Reference: Beaver Valley Power Station, Unit No. 1  
Docket No. 50-334  
Response To Requests For Information On Station Service Bus Voltages

Beaver Valley P.S. - Unit #1  
 Duquesne Light Reply To NRC Letters  
Dated July 5, 1979, and August 8, 1979

FILE NO. O.F.E. NO. GRAPH #1

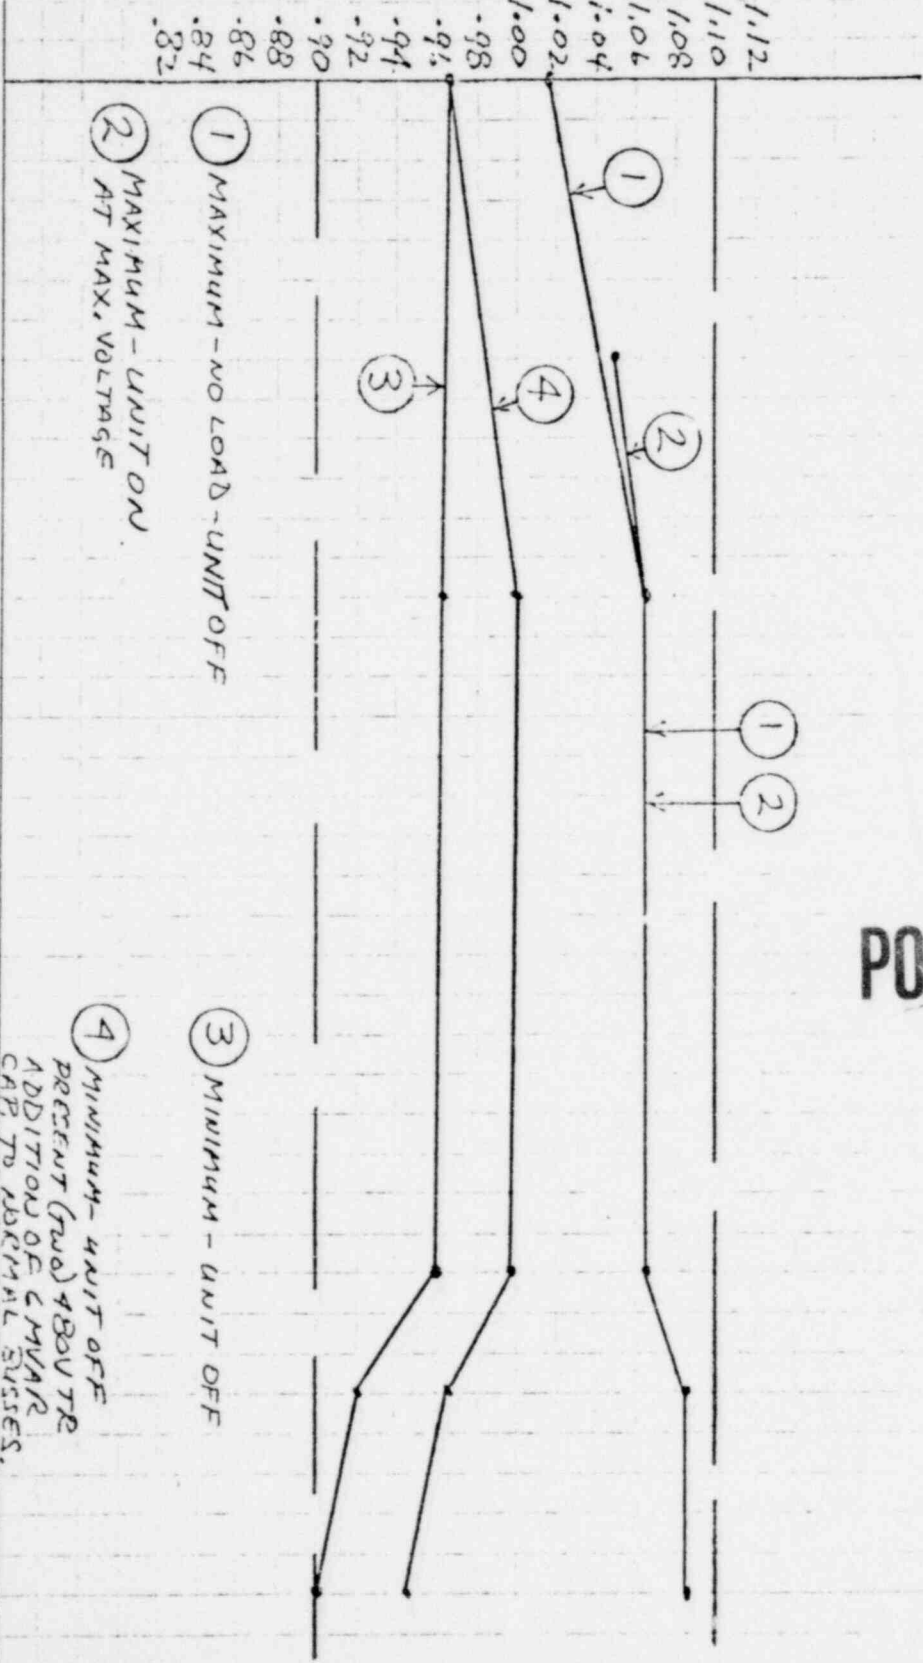
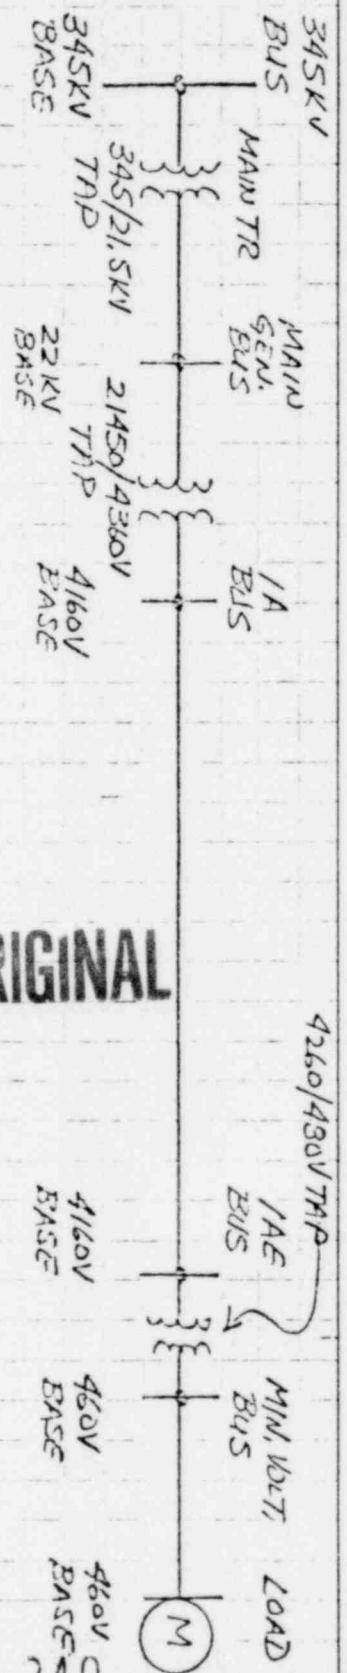
Two graphs are attached. One illustrates the voltage profile when supplied from the 22kV lead banks (GRAPH #1). The other illustrates the profile when supplied from the 138kV banks (GRAPH #2).

As illustrated by curve #1 in both graphs, the voltages do not exceed 110%.

Curve #4 on both graphs shows the results that would be obtained by adding capacitors to the normal busses.

1	JOB TITLE	BEAVER VALLEY P.S. - UNIT #1	FILE NO.	GRAPH # 2
2	LOCATION		C.O./J.O.	
3	SUBJECT	VOLTAGE STUDY	COMPILED BY:	9/27/79
4	DEPARTMENT		CHECKED BY:	DATE: 10/3/79
5	VISION		REVISOR BY:	DATE:

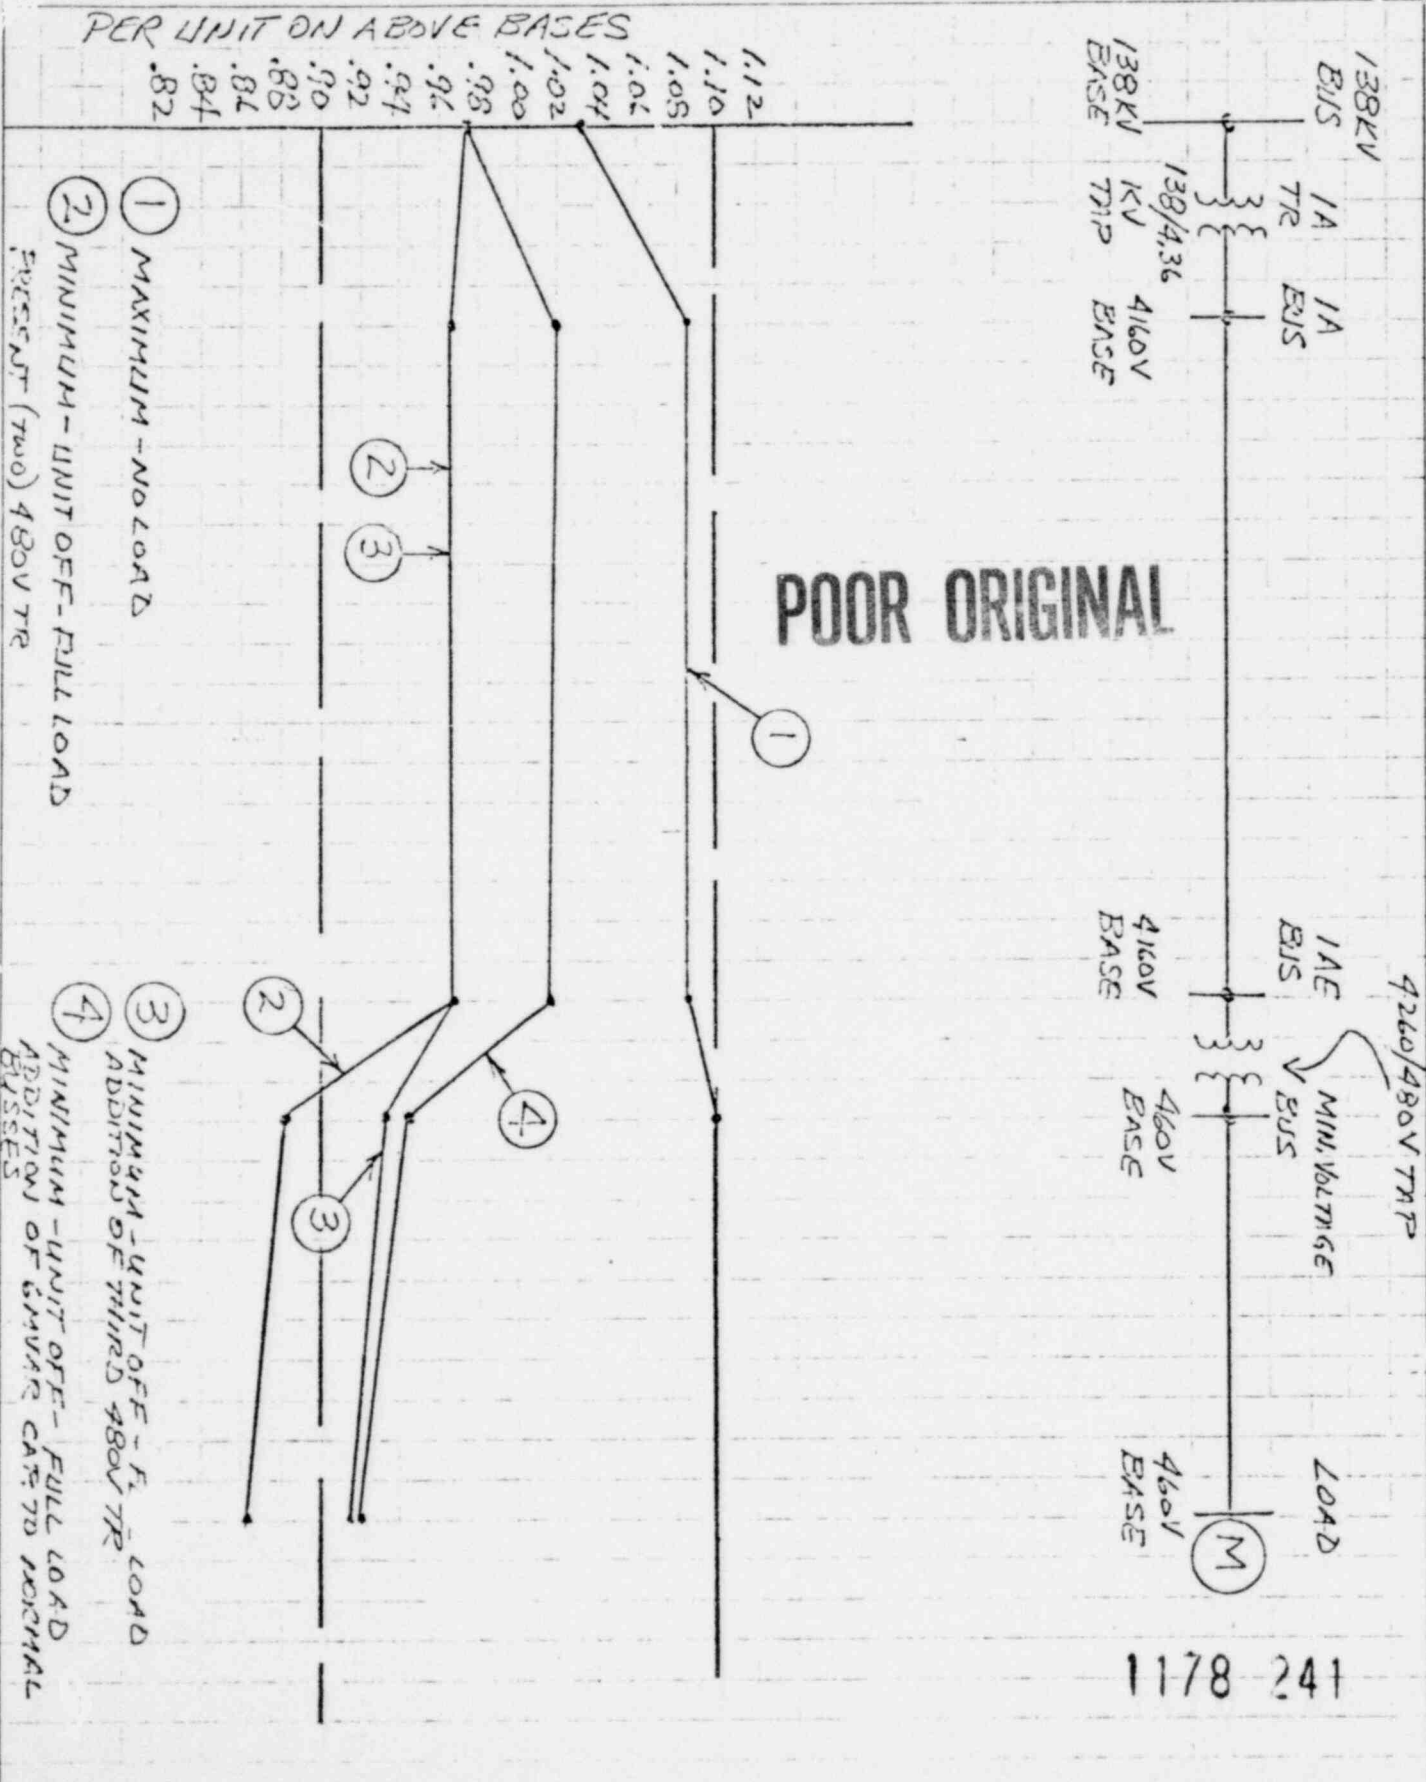
The highest voltage will appear on the station service busses when they are supplied from the 138kV system busses. For a no load condition, the voltage profile is illustrated on the attached graph #2. This represents the maximum credible voltages the emergency busses will be subjected to. Under this condition the voltage does not exceed 110%. It must be remembered that since this is a no load condition, motors are not actually being subjected to this voltage until they are started, and then the no load condition no longer exists.

We stated previously that the minimum voltage occurs when the busses are supplied from the 138kV system. This is illustrated by curve #2 on graph #2.

Curve #3 of graph #2 shows the results of adding a third 480V transformer to the emergency system.

BEAVER VALLEY P.S.  
 UNIT #1  
 PROPOSED UNDERVOLTAGE PROT.  
 May 10-8-79

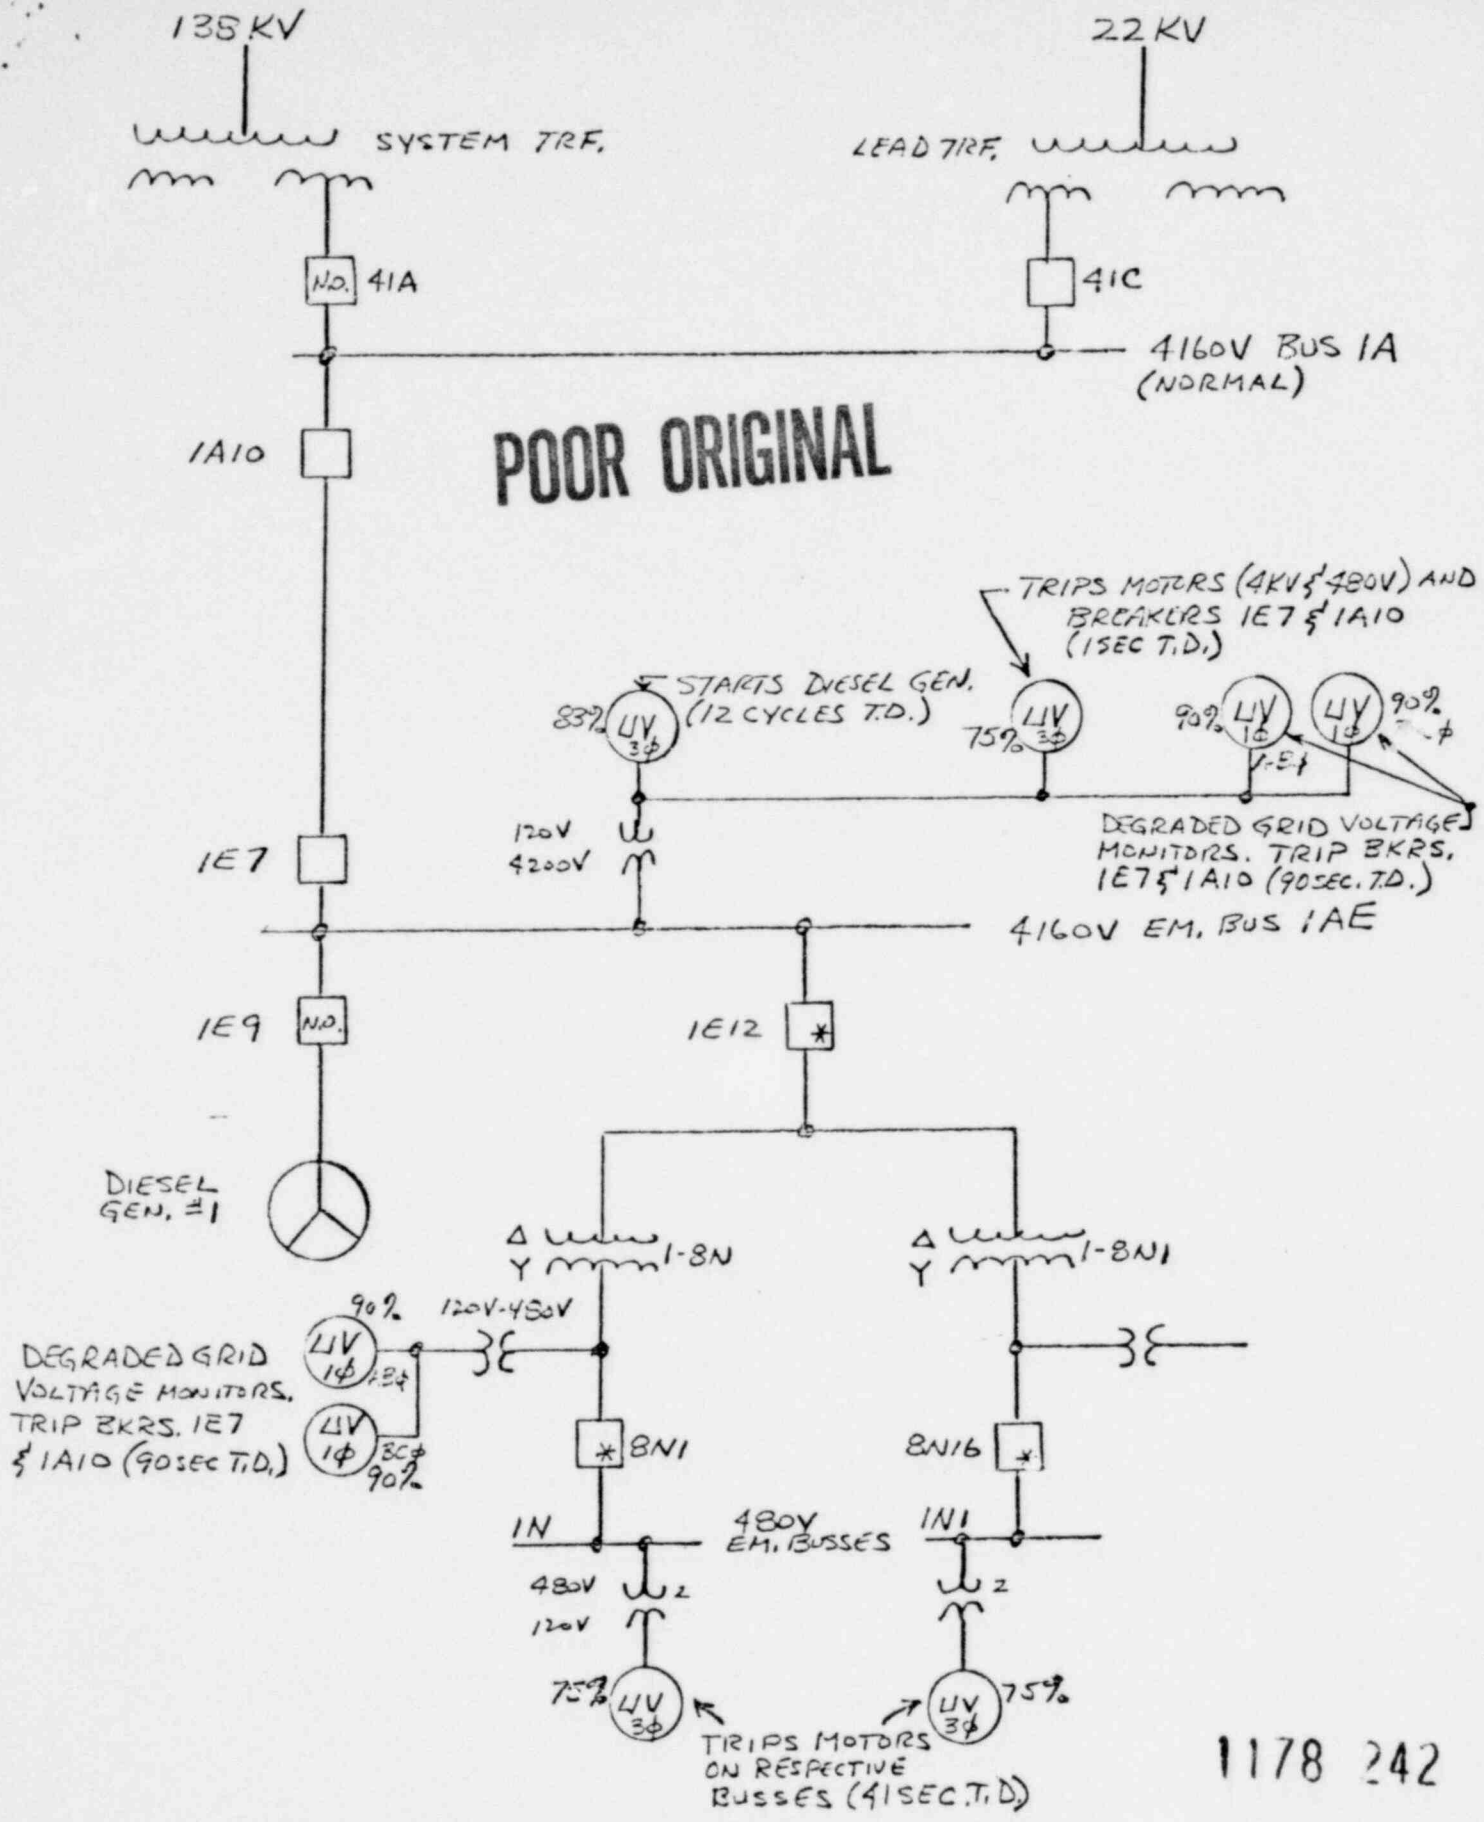
The proposal described below relates to busses 1AE, 1N and 1N1, but with the understanding that busses 1DF, 1P and 1P1 will be made similar. (Please refer to attached diagram.)

1. We will provide two (2) single phase undervoltage relays connected to potential transformers presently on 4160V bus 1AE. We will also provide two (2) single phase undervoltage relays connected to potential transformers on the secondary of transformer 1-8N. These relays will meet the requirements of IEEE 279-1971.

2. The contacts of the two relays on the 4160V bus 1AE will be connected in series (coincident logic). The contacts of the two relays on the secondary of transformer 1-8N will be connected similarly.

3. The two series circuits of (2.) above will operate a timing relay set for 90 seconds time delay on pickup. The timing relay will initiate trip of breakers 1E7 and 1A10. This will remove the offsite source from the emergency busses. With reference to the stipulation that time delays not exceed FSAR time limitations, the accident conditions addressed in the FSAR are based on complete loss of offsite power. For these conditions, existing undervoltage protection will not exceed the limits imposed for reactor safety. The Design Basis Accident (29 in. double ended rupture and loss of offsite power) requires the following equipment available in the times noted:
